Subject: Application for F-431 Transportation Package – Second Request for Additional Information

Supplemental Safety Analysis Report for the F430 Transport Package

IN/TR 6088 F430 (C)

Supplementary Safety Analysis Report for the F-430 Transport Package

Figure 2: GC40 Modified Design (field retrofit and in-house) Prepared For Shipment

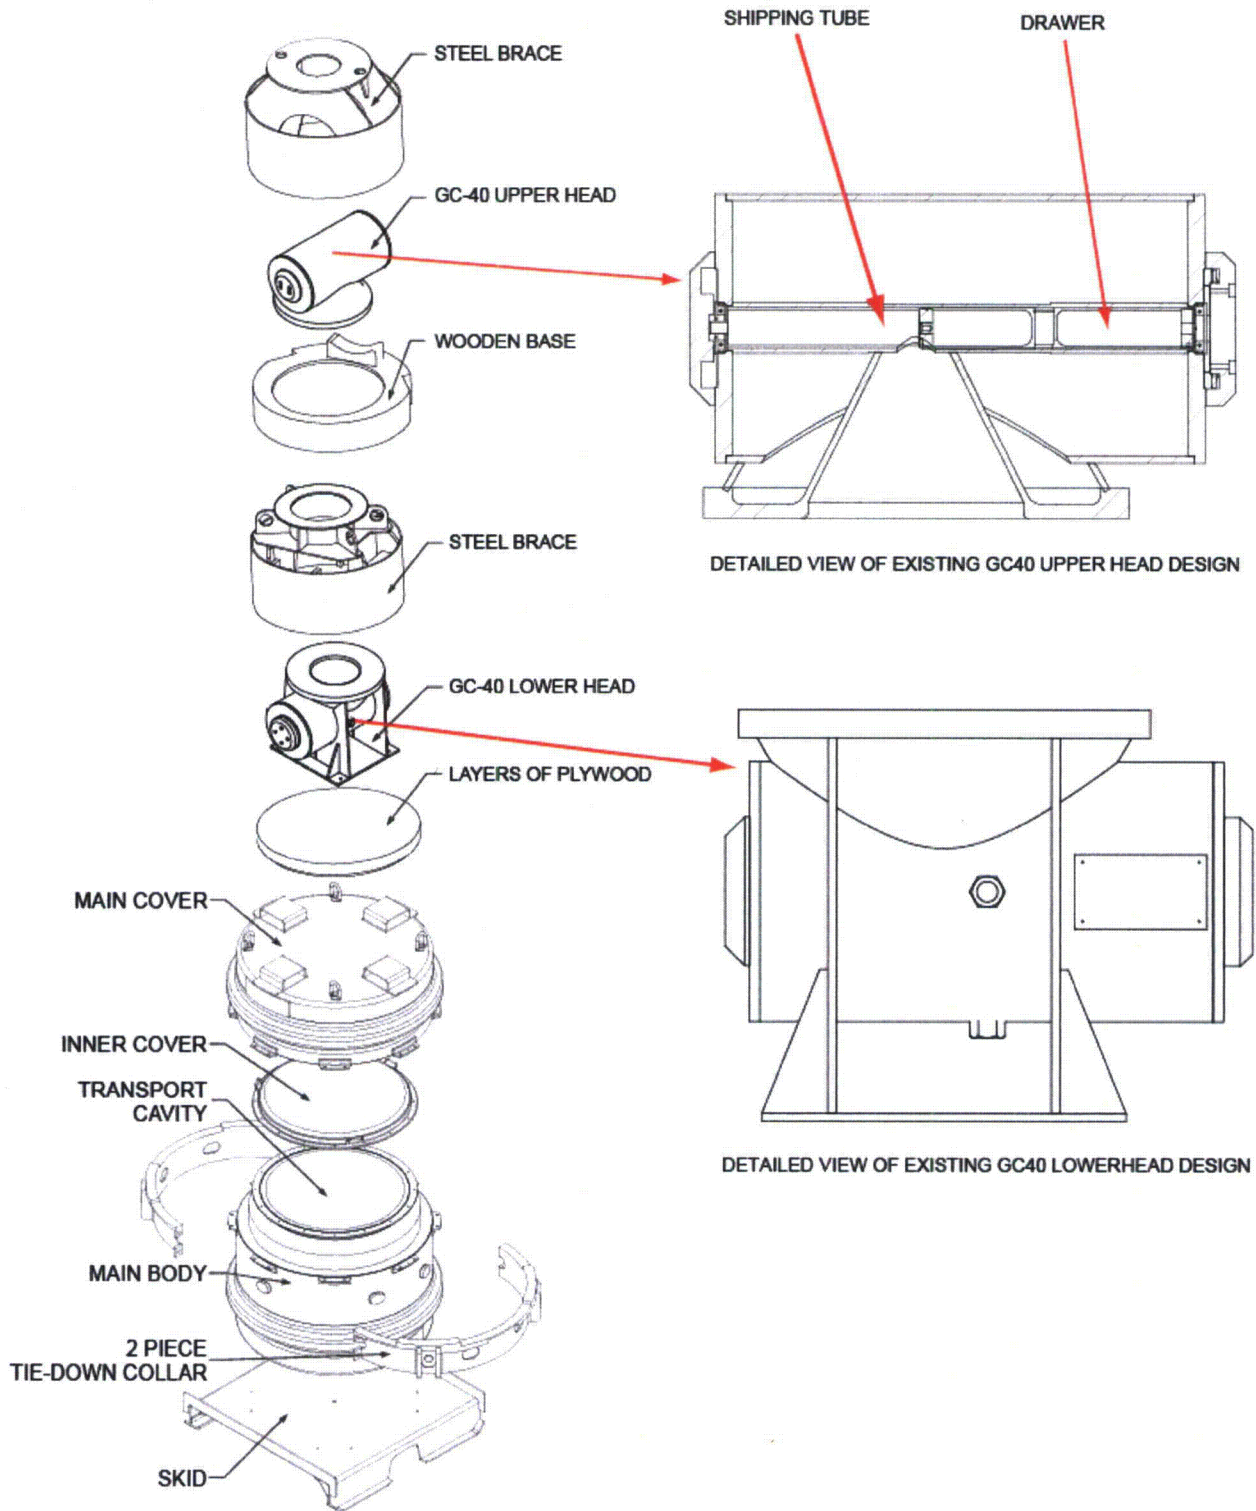
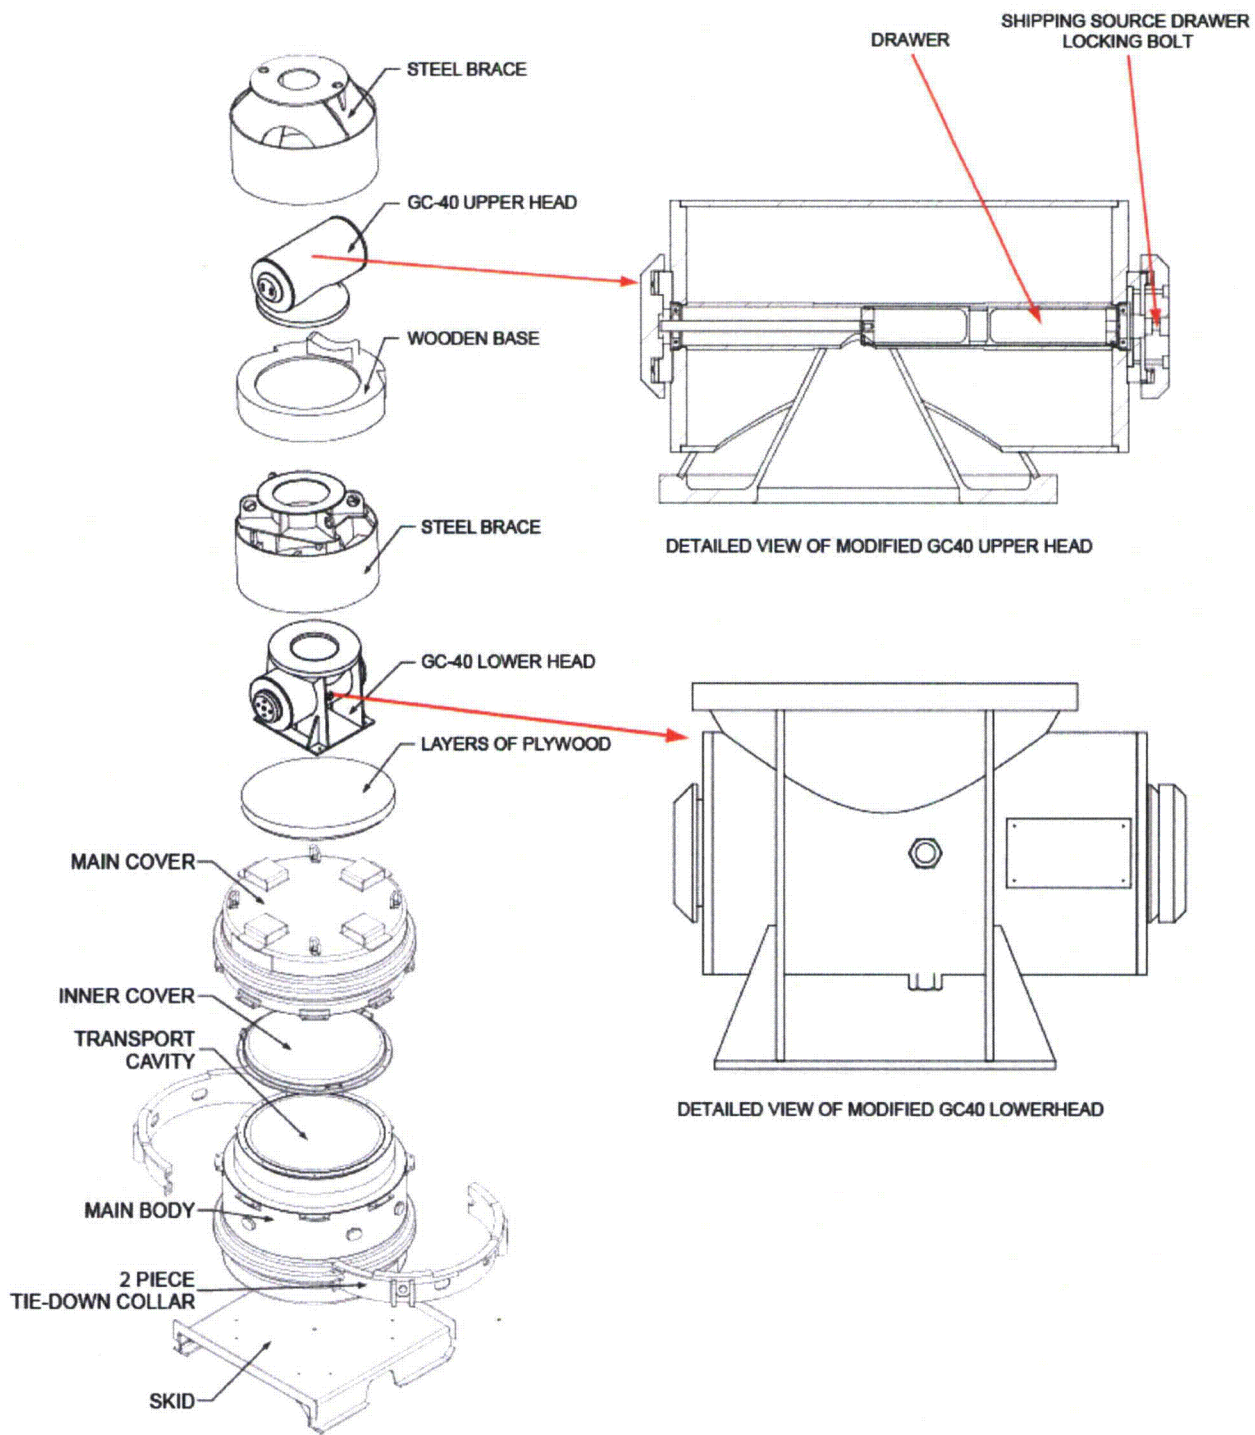
The proposed new design of the GC40 incorporates many additional fasteners with security features. Because of the new features, it is not practicable to remove the mounting plates for transport (Refer to Figure 2). Therefore the Shipping Tube cannot be installed on upgraded units. However, the Source Drawer Assembly is secured from movement with Shipping Plates. The new Shipping Plates are very similar to the existing Shipping Plates. They fasten to the GC40 shielding head using the same fasteners as before (four 3/8-16 socket head cap screws. Additionally, a 1/2-20 socket head cap screw fastens through one of the Shipping Plates into the Source Drawer. This further secures the source drawer.

An important feature of the existing Shipping Plate is the fact that it is partly recessed in a counterbore on the GC40 shielding head. In the event of an impact, the force on the shipping plate is borne by the interface with this counterbore, as well as the fasteners. The new Shipping Plates maintain this feature (refer to Figure 2).

Because the Mounting Plates are left in place for transport, the weight of the GC40 shielding heads each increases by approximately 7 kg (15 lb.). The effect of this slight increase in weight is discussed in Chapter 2.

Because it is not practical to remove the extra security hardware, it is not possible to install the Shipping Tube (or “Tube Spacer”) inside the bore of the GC40 heads. On devices that have the new security hardware, the step for installing the Shipping Tube is omitted.

The upgraded GC40 devices will use the new shipping plate. The procedure for installing the new shipping plates is unchanged, except that one additional ½-20 UNF screw is installed.
